Utility Company Name Wisconsin Public Service Corporation - Electricity	PLEASE RETURN THIS WORKSHEET BY January 29, 2021
Project Description Design Project ID: 9210-19-00 Construction Project ID: 9210-19-71 W MASON ST, CITY OF GREEN BAY BEAVER DAM CREEK BRIDGE STH 32, Brown County	RETURN TO Becky Reese Division of Transportation System Development Northeast Region 944 Vanderperren Way Green Bay WI 54304

W MASON ST, CITY OF GREEN BAY
BEAVER DAM CREEK BR
STH 32
BROWN COUNTY

WPS ELECTRIC REVIEW
12/3/2020

PROJECT PLAN
FOR
DESIGN OF UTILITY FACILITY
ALTERATIONS OR RELOCATIONS

SHEET 3 OF 4
PLAN SHEET PRODUCED
BY WISDOT-NE REGION

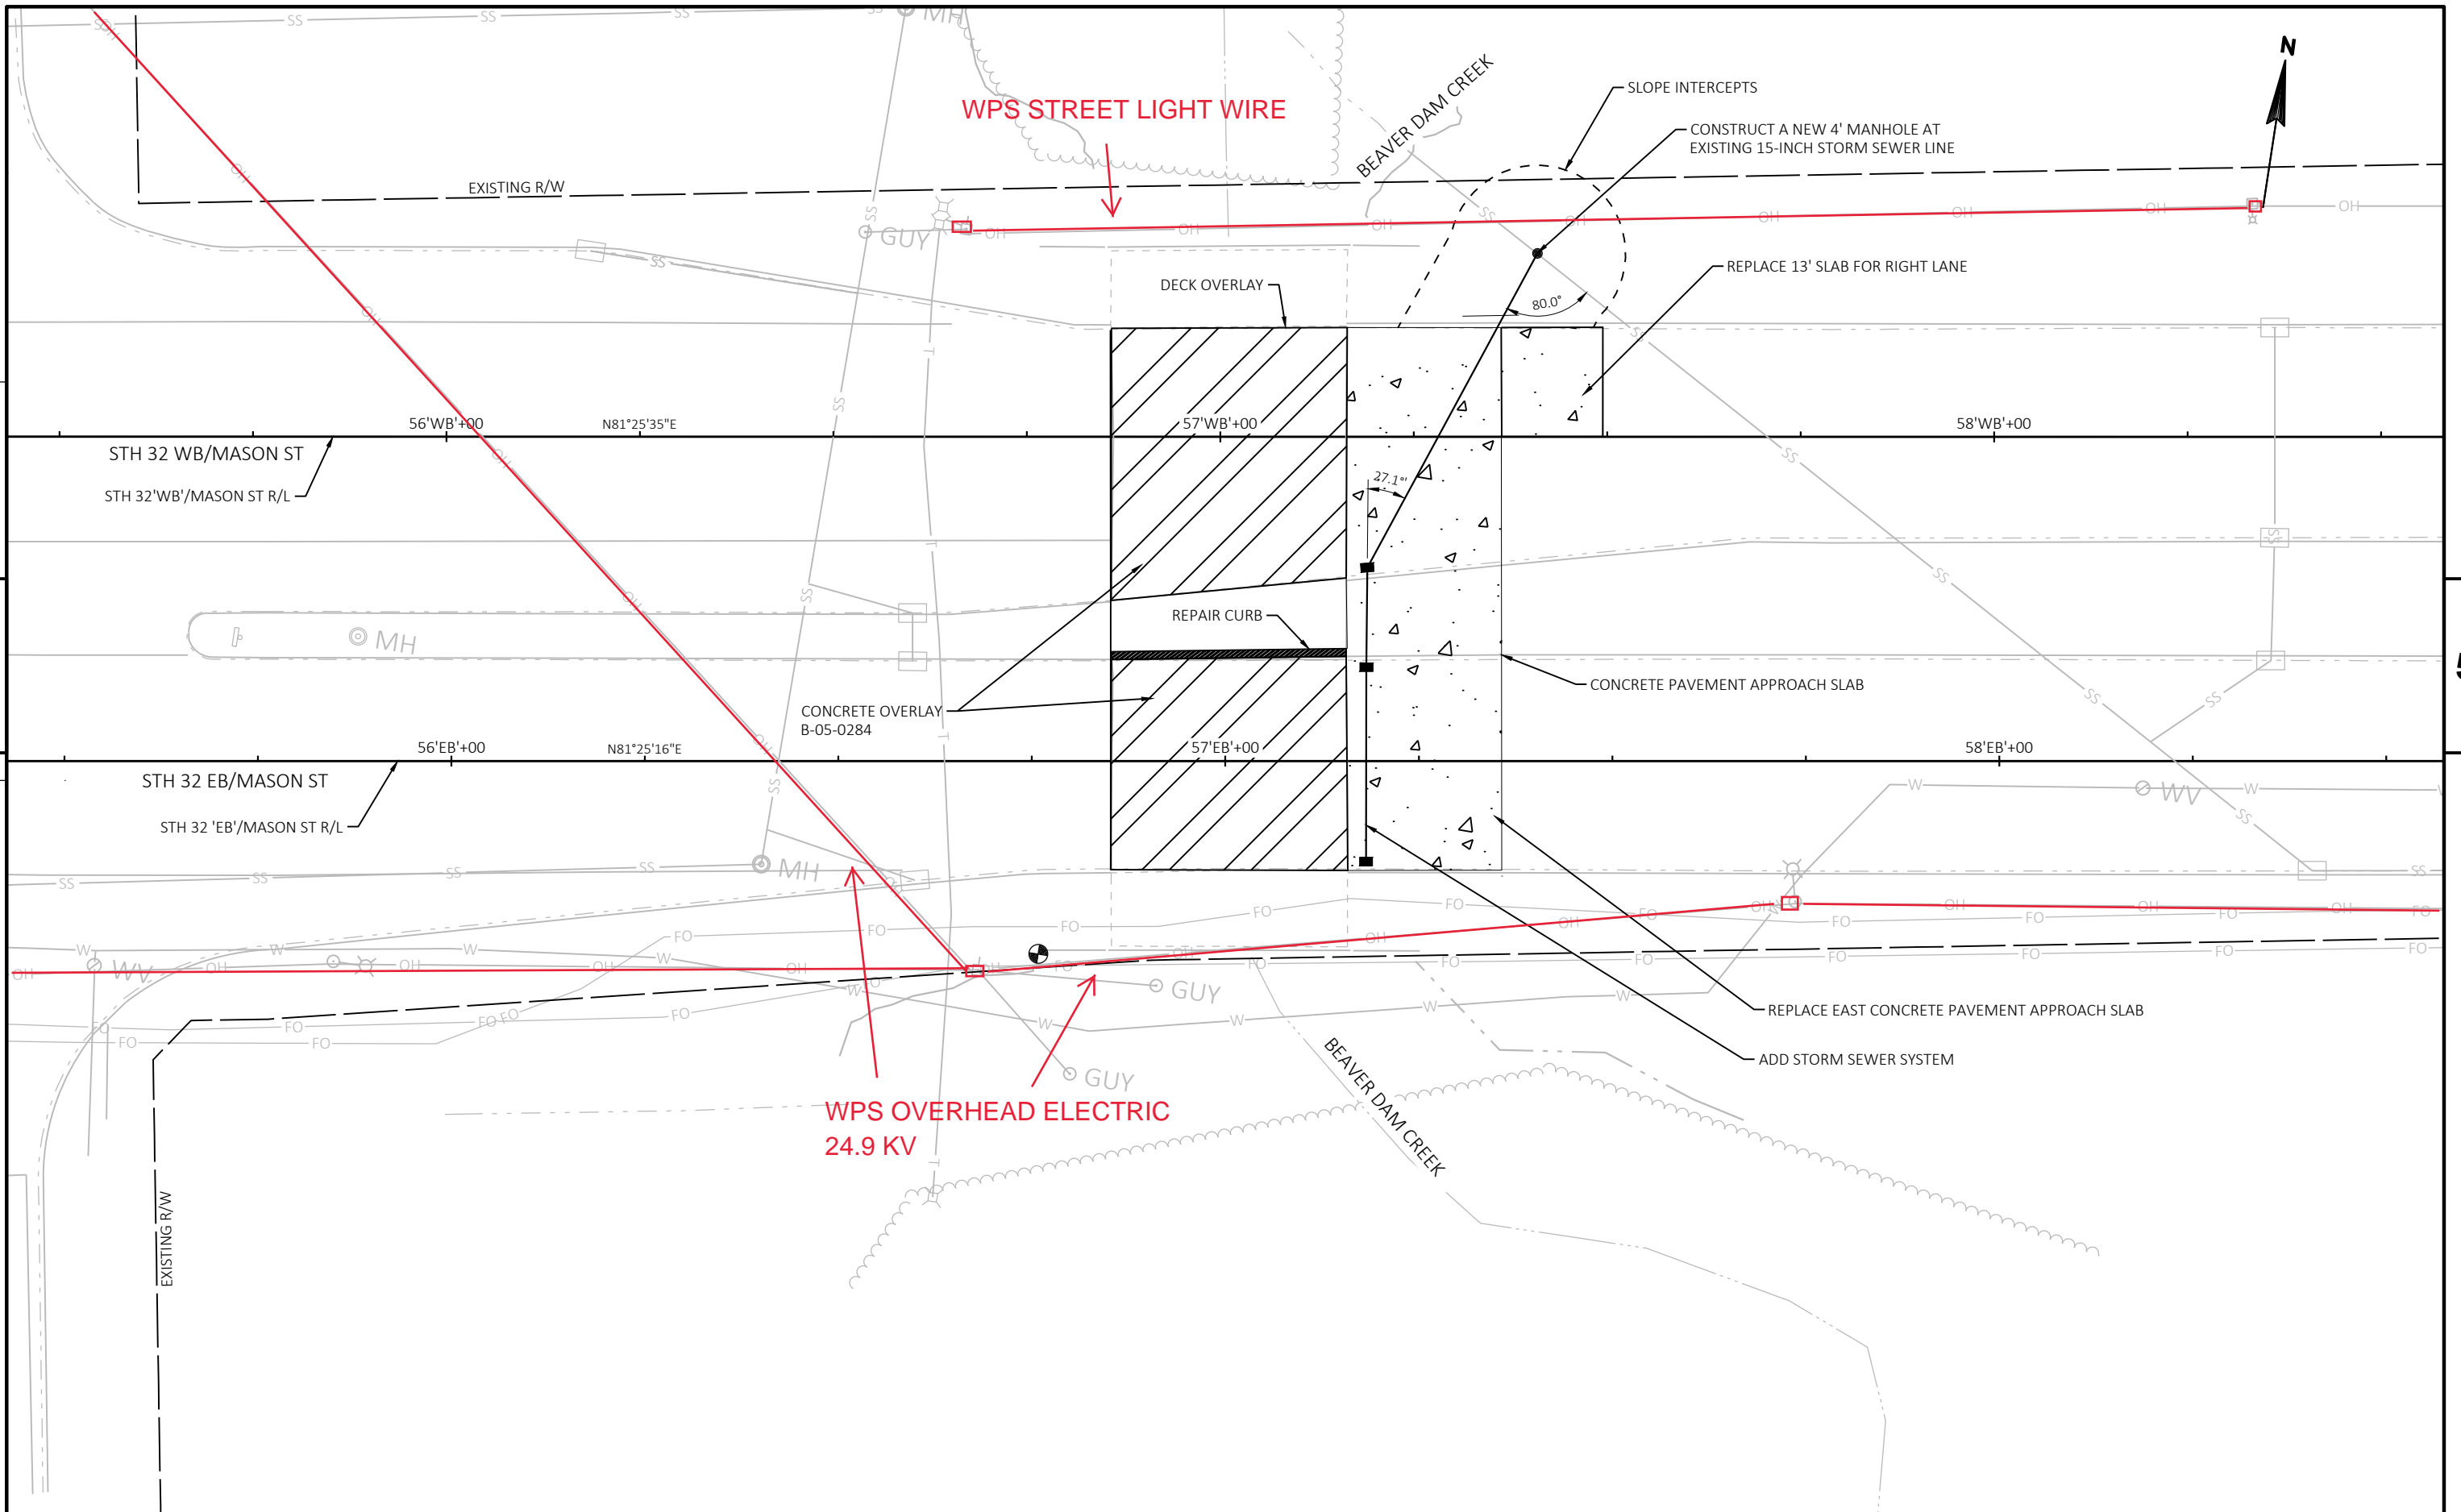
WPS has reviewed the work plans for conflicts with WPS electric facilities. There are overhead electric facilities near the work site and highlighted on the submitted work plan. There are no anticipated conflicts identified.

WPS electric facilities appear to be captured correctly on the plans.
